# UNITED STATES PATENT AND TRADEMARK OFFICE

APPLICATION NO.	FILING DATE	FIRST NAMED INVENTOR	ATTORNEY DOCKET NO.	CONFIRMATION NO.
10/558,893	10/13/2006	Michael Huth	2003P06127W0US	6326
22116 7590 03/10/2010				
SIEMENS CORPORATION				
INTELLECTUAL PROPERTY DEPARTMENT				
170 WOOD AVENUE SOUTH				
ISELIN, NJ 08830				
EXAMINER				
SUNG, GERALD LUTHER				
ART UNIT		PAPER NUMBER		
3741				
MAIL DATE		DELIVERY MODE		
03/10/2010		PAPER

### Office Action Summary

### **DETAILED ACTION**

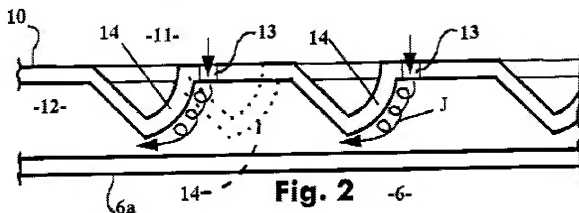
11. Regarding claim 13, the Applicant's amendments to claim 10 require the flow element to be placed on the combustion chamber wall; however, the limitation "the heat shield element is a single-shell hollow vessel... that the flow element is disposed" found in claim 13 renders the claims indefinite because it is unclear whether the flow element is disposed on the inner liner (composed of heat shields) or the outer combustion chamber wall.
